RELIABLE ENERGY'S COMMENTS
ON INDIANA MICHIGAN POWER'S 2021 INTEGRATED RESOURCE PLAN
August 3, 2022

Reliable Energy, Inc.’s Comments on I&M’s March 9, 2021 IRP Stakeholder Meeting and Slide Deck

Figure 5. I&M’s Preferred Portfolio - PJM Capacity Position (UCAP)

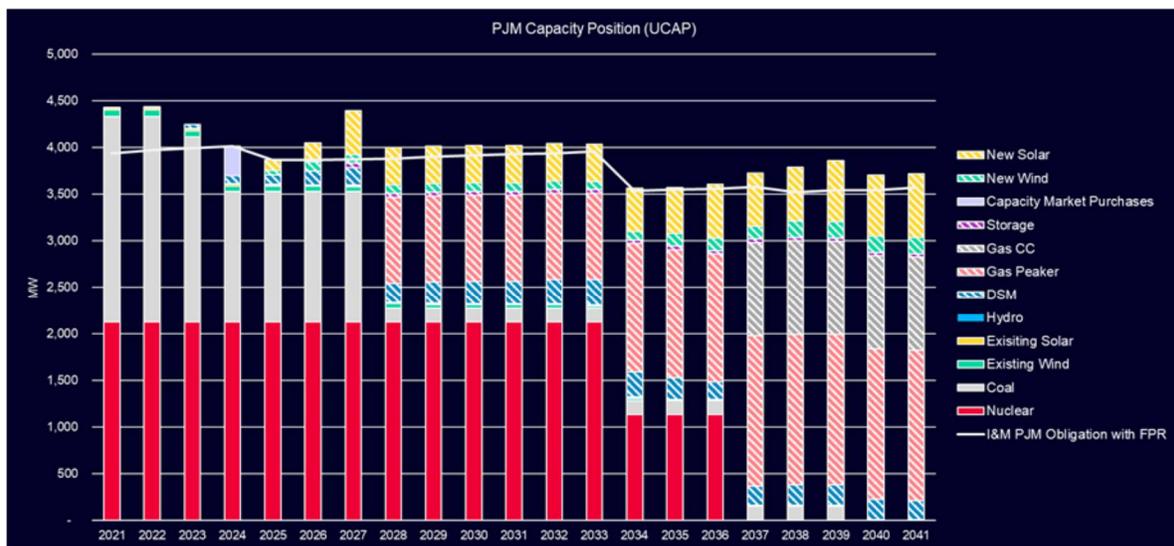
The obvious problems with the Preferred Portfolio are the reliance on natural gas additions including both Combustion Turbines (CTs) and CCGTs, throughout the forecast period and the very significant renewable additions over relatively narrow periods:

IRP Objectives	IRP Metric
Affordability	NPV-RR
Rate Stability	95 th percentile value of NPV-RR
Sustainability Impact	CO2 Emissions
Market Risk Minimization	Spot Market Exposure (Purchases/Sales)
Reliability	Reserve Margin
Resource Diversity	Mix of Adequate Resources

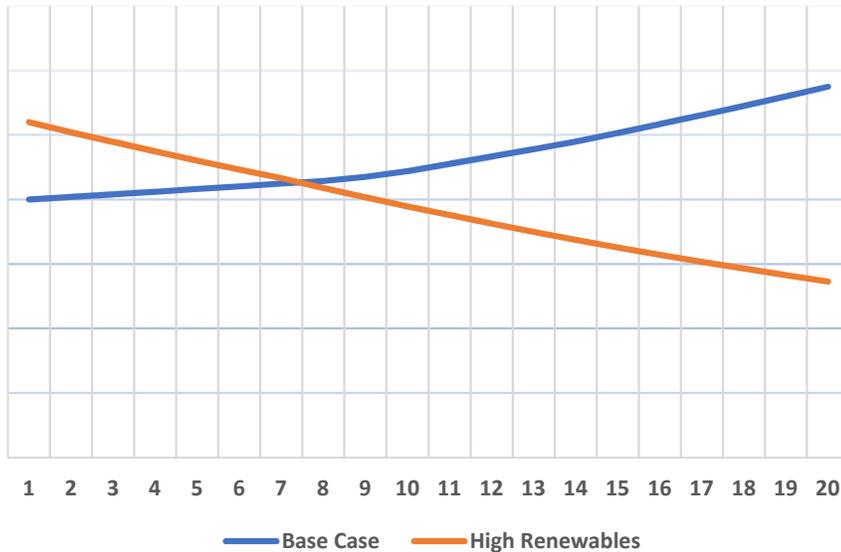
Reliable Energy has the following problems with the proposed metrics and/or what they are being used to consider.

While it is appropriate for IMP to consider the impact to customer bills, the NPV-RR does not provide this.

Again a statistical analysis of the NPV is being called upon to demonstrate rate stability. Rate stability should reflect stable prices over the planning period. The 95th percentile of the NPV does not show this.

IMP proposed to use spot market exposure (which it defines as purchases versus sales) as the metric for determining market risk. It is not obvious why this metric, as defined by IMP, is a measure of market risk minimization. Typically, market risk minimization is measured by the diversity, resilience, and reliability of generation. Unless IMP can demonstrate why a spot market exposure metric is appropriate, Reliable Energy believes an alternative metric for market risk be developed.

IMP proposes the metric for Reliability be Reserve Margin. Utilities have a reserve margin obligation. It is not clear the relevance of achieving its required reserve margin is relevant as all cases must meet reserve margin to be acceptable. Reliability metrics should focus on the type of generation, on-site inventory, protection against gas supply disruptions, and insuring adequate transmission upgrades.

Resource Diversity is a separate metric for IMP. As noted above, Reliable Energy believes that Resource Diversity is part of Market Risk Minimization and Reliability, not a separate stand-alone metric.

Fundamentals Forecast

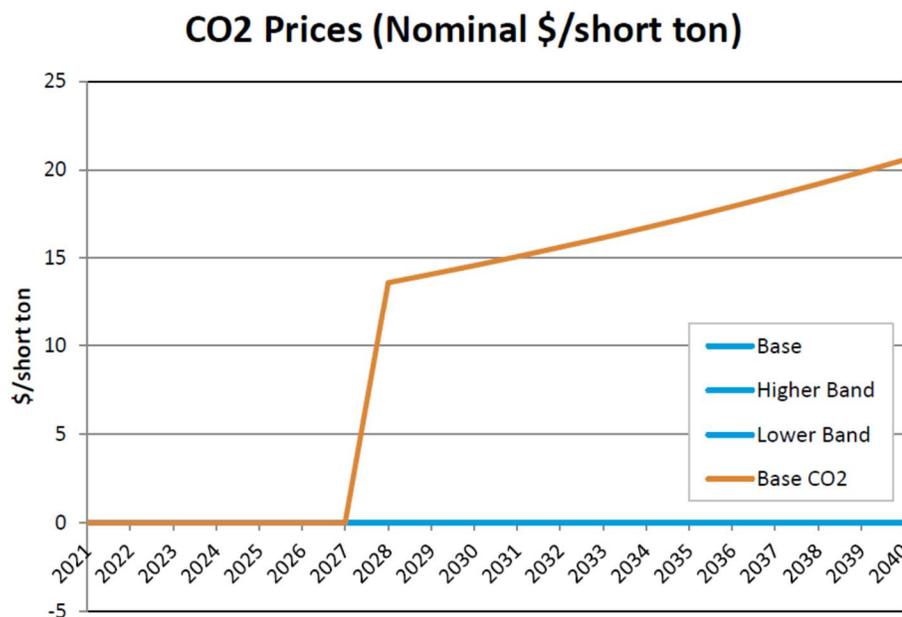
The reliance on EIA price forecasts for IRPs is understandable as this is a public source. There are a number of problems, however, with such reliance and IMP's approach.

- The EIA reference price forecast does not reflect rules and regulations not in place.
- New regulations, such as a carbon regime, will affect future fuel supply and demand, hence prices. Therefore, the Base Carbon Case which uses the reference price with a carbon adder will not capture that market dynamic.
- Historically coal prices and natural gas prices are not correlated. Adjusting the base fuel prices upward and downward will miss a consequence of rising natural prices with flat coal prices, a scenario which is considered a real possibility.
